City of Alachua

Planning & Community Development Department Staff Report

Planning & Zoning Board Hearing Date: December 10, 2019
Quasi-Judicial Hearing

SUBJECT: A request for a Site Plan for the construction of three buildings totaling $\pm 25,028$ square feet with employee and customer parking, storm water management facility improvements, paving, grading, landscaping and associated utility infrastructure

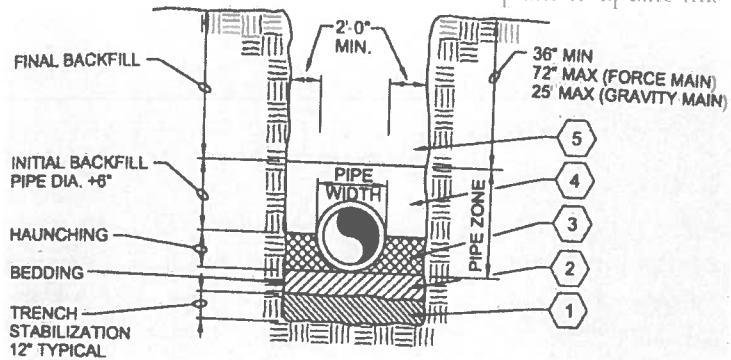
NO.	COMMENTS
1.	<p>Previous Submittal Comment</p> <p>Sheet C0.10 Water and Wastewater General Notes</p> <ul style="list-style-type: none">• Modify Note 1 so it includes a reference to "City of Alachua, Department of Public Services, Requirements for Design and Construction, Potable Water, Reclaimed Water and Wastewater."• Minor Comment, Note 13, change spelling to "CONTRACTOR". <p>Current Submittal Comment</p> <p>Approved</p>
2.	<p>Previous Submittal Comment</p> <p>Sheet C0.10 Electric Service General Notes</p> <ul style="list-style-type: none">• It appears that someone other than "GRU Energy Delivery" is providing the electric design. Thus, please modify Note 2. <p>Current Submittal Comment</p> <p>Approved</p>

NO.	COMMENTS
3.	<p>Previous Submittal Comment</p> <p>Sheet C0.11 Wastewater Legend</p> <ul style="list-style-type: none"> Existing gravity wastewater mains are called out as "SS". Please call out on the abbreviation list <p>Current Submittal Comment</p> <p>Approved</p>

4.	<p>Previous Submittal Comment</p> <p>Sheet C2.30</p> <ul style="list-style-type: none"> Suggest that a detail be added for a cleanout. Suggest that a detail be added for a PRZ Backflow Preventer. <p>Previous August Submittal Comment</p> <ul style="list-style-type: none"> Cleanout: DWG C3.10 says that City of Alachua (CoA) maintenance ends at the existing SS lines, meaning CoA is not responsible for maintaining the laterals. Please confirm. If CoA is responsible for maintaining the laterals, the CoA would prefer that tracer wires be added to the laterals. As requested, a detail for a backflow preventer has been added to C 2.30. Please confirm that the CoA is responsible to maintain the backflow preventers that are shown on several insets on C3.10. If so, the applicable CoA detail requires freeze protection. The backflow preventers as shown are 1-inch, which are susceptible to freezing. CoA's standard detail requires freeze protection for above ground pipe, but does not call out methods. Suggest that this issue be discussed at the next planning meeting, or call Tom Ridgik @ (352) 418-6162. <p>Revise and Resubmit after discussion.</p> <p>Current Submittal Comment</p> <p>Approved</p>

5.	<p>Previous Submittal Comment</p> <p>CoA Standard Detail 420 is in need of revision. The CoA plans to update this detail in the soon-to-be-</p>

NO.	COMMENTS
	<p>revised Design and Construction Manual. In the interim, please replace the detail as shown below. (Note: CHW may have already revised this detail in a previous project.)</p> <p>NOTES:</p> <ol style="list-style-type: none"> 1. TRENCH STABILIZATION SHALL BE PROVIDED TO A DEPTH OF 12-INCHES. THE MATERIAL SHALL BE NO. 57 STONE. 2. BEDDING SHALL BE A MINIMUM OF 6-INCHES AND COMPOSED OF IMPORTED GRANULAR FILL. COMPACT TO 95% STANDARD PROCTOR, AASHTO T-99. 3. HUNCHING PORTION OF THE PIPE ZONE SHALL BE PLACED TO THE SPRINGLINE OF THE PIPE AND COMPOSED OF IMPORTED GRANULAR FILL. COMPACT TO 95% STANDARD PROCTOR ASSHTO T-99. 4. INITIAL BACKFILL: COMMON FILL COMPACTED TO 95% (98% UNDER PAVEMENT) OF THE MAXIMUM DENSITY AS PER AASHTO T-180. FROM THE SPRINGLINE OF THE PIPE TO TWO (2) FEET ABOVE THE PIPE THE SOIL SHALL BE CAREFULLY BACKFILLED IN 6-INCH LIFTS AND THE SOIL CONSOLIDATED WITH THE HAND OPERATED TAMPING MACHINE (OR AS REQUIRED BY CITY, COUNTY, OR STAT INSPECTORS). 5. FINAL BACKFILL: COMMON FILL COMPACTED TO 95% (98% UNDER PAVEMENT) OF THE MAXIMUM DENSITY AS PER AASHTO T-180. AFTER PLACEMENT AND COMPACTION OF THE INITIAL BACKFILL, THE BALANCE OF THE BACKFILL MATERIAL MAY BE MACHINE PLACED OR AS REQUIRED BY THE INSPECTOR AND SHALL NOT CONTAIN ANY ROCKS OR DEBRIS. 6. WATER SHALL NOT BE PERMITTED IN THE TRENCH DURING CONSTRUCTION. 7. ALL PIPE TO BE INSTALLED WITH BELL FACING UPSTREAM TO THE DIRECTION OF THE FLOW. 8. DEPTH FOR REMOVAL OF UNSUITABLE MATERIAL SHALL GOVERN DEPTH OF BEDDING ROCK BELOW THE PIPE. UTILITIES SHALL DETERMINE IN THE FIELD REQUIRED REMOVAL OF UNSUITABLE MATERIAL TO REACH SUITABLE FOUNDATION. THE BOTTOM OF THE TRENCH SHALL NOT BE EXCAVATED BELOW THE SPECIFIED GRADE. IF UNDERCUTTING OCCURS, THE BOTTOM OF THE TRENCH SHALL BE BROUGHT UP TO THE ORIGINAL GRADE WITH APPROVED MATERIAL AND THOROUGHLY COMPACTED TO A MINIMUM OF 95% MODIFIED PROCTOR. 9. FINAL RESTORATION IN IMPROVED AREAS SHALL BE IN COMPLIANCE WITH ALL APPLICABLE REGULATIONS OF GOVERNING AGENCIES. <p>Previous August Submittal Comment</p> <p>The revised detail now shown on C 2.30 does not call out the trench width. Please add the dimensions called out on the above detail (2 feet 0 inches on either side of the pipe).</p> <p>Approved as Noted.</p> <p>Current Submittal Comment</p> <p>Approved</p>

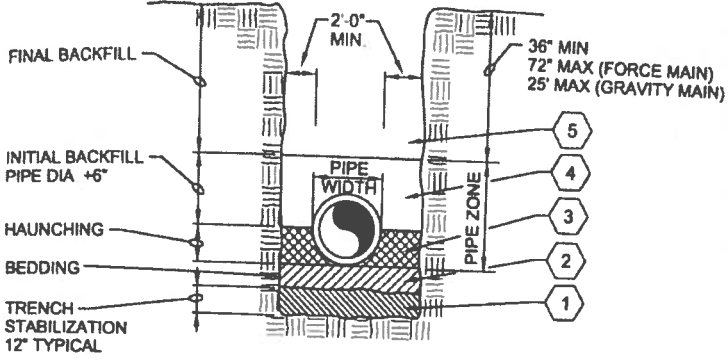
NO.	COMMENTS
1.	Sheet C0.10 Water and Wastewater General Notes <ul style="list-style-type: none">Modify Note 1 so it includes a reference to "City of Alachua, Department of Public Services, Requirements for Design and Construction, Potable Water, Reclaimed Water and Wastewater."Minor Comment, Note 13, change spelling to "CONTRACTOR".
2.	Sheet C0.10 Electric Service General Notes <ul style="list-style-type: none">It appears that someone other than "GRU Energy Delivery" is providing the electric design. Thus, please modify Note 2.
3.	Sheet C0.11 Wastewater Legend <ul style="list-style-type: none">Existing gravity wastewater mains are called out as "SS". Please call out on the abbreviation list
4.	Sheet C2.30 <ul style="list-style-type: none">Suggest that a detail be added for a cleanout.Suggest that a detail be added for a PRZ Backflow Preventer.

NO.	COMMENTS
5.	<p>CoA Standard Detail 420 is need of revision. The CoA plans to update this detail in the soon-to-be-revised Design and Construction Manual. In the interim, please replace the detail as shown below. (Note: CHW may have already revised this detail in a previous project.)</p>  <p>NOTES:</p> <ol style="list-style-type: none"> 1. TRENCH STABILIZATION SHALL BE PROVIDED TO A DEPTH OF 12-INCHES. THE MATERIAL SHALL BE NO. 57 STONE. 2. BEDDING SHALL BE A MINIMUM OF 6-INCHES AND COMPOSED OF IMPORTED GRANULAR FILL. COMPACT TO 95% STANDARD PROCTOR, AASHTO T-99. 3. HAUNCHING PORTION OF THE PIPE ZONE SHALL BE PLACED TO THE SPRINGLINE OF THE PIPE AND COMPOSED OF IMPORTED GRANULAR FILL. COMPACT TO 95% STANDARD PROCTOR ASSHTO T-99. 4. INITIAL BACKFILL: COMMON FILL COMPACTED TO 95% (98% UNDER PAVEMENT) OF THE MAXIMUM DENSITY AS PER AASHTO T-180. FROM THE SPRINGLINE OF THE PIPE TO TWO (2) FEET ABOVE THE PIPE THE SOIL SHALL BE CAREFULLY BACKFILLED IN 6-INCH LIFTS AND THE SOIL CONSOLIDATED WITH THE HAND OPERATED TAMPING MACHINE (OR AS REQUIRED BY CITY, COUNTY, OR STAT INSPECTORS). 5. FINAL BACKFILL: COMMON FILL COMPACTED TO 95% (98% UNDER PAVEMENT) OF THE MAXIMUM DENSITY AS PER AASHTO T-180. AFTER PLACEMENT AND COMPACTION OF THE INITIAL BACKFILL, THE BALANCE OF THE BACKFILL MATERIAL MAY BE MACHINE PLACED OR AS REQUIRED BY THE INSPECTOR AND SHALL NOT CONTAIN ANY ROCKS OR DEBRIS. 6. WATER SHALL NOT BE PERMITTED IN THE TRENCH DURING CONSTRUCTION. 7. ALL PIPE TO BE INSTALLED WITH BELL FACING UPSTREAM TO THE DIRECTION OF THE FLOW. 8. DEPTH FOR REMOVAL OF UNSUITABLE MATERIAL SHALL GOVERN DEPTH OF BEDDING ROCK BELOW THE PIPE. UTILITIES SHALL DETERMINE IN THE FIELD REQUIRED REMOVAL OF UNSUITABLE MATERIAL TO REACH SUITABLE FOUNDATION. THE BOTTOM OF THE TRENCH SHALL NOT BE EXCAVATED BELOW THE SPECIFIED GRADE. IF UNDERCUTTING OCCURS, THE BOTTOM OF THE TRENCH SHALL BE BROUGHT UP TO THE ORIGINAL GRADE WITH APPROVED MATERIAL AND THOROUGHLY COMPACTED TO A MINIMUM OF 95% MODIFIED PROCTOR. 9. FINAL RESTORATION IN IMPROVED AREAS SHALL BE IN COMPLIANCE WITH ALL APPLICABLE REGULATIONS OF GOVERNING AGENCIES.

NO.	COMMENTS
6.	Sheet C3.10 <ul style="list-style-type: none"> Inset CC: Item 7 is a 12- x 3-inch tap and wet valve. Inasmuch as 3-inch piping and fittings are not a CoA standard, please replace with a 12- x 4-inch tap and wet valve. Please select downstream piping such that 3-inch piping is not installed. Please change fitting schedule.
7.	Sheet C3.11 <ul style="list-style-type: none"> Inset CC: Same comment as above.
8.	Sheets C3.10 and C3.11 <ul style="list-style-type: none"> Please show the existing easement on these two drawings. Also add note referencing this easement: namely, "Alachua County Clerk of the Court, Book 3866, Page 12".
10.	Sheet E-1: Please modify Construction Notes on this Drawing as per Attachment 1.
END OF COMMENTS
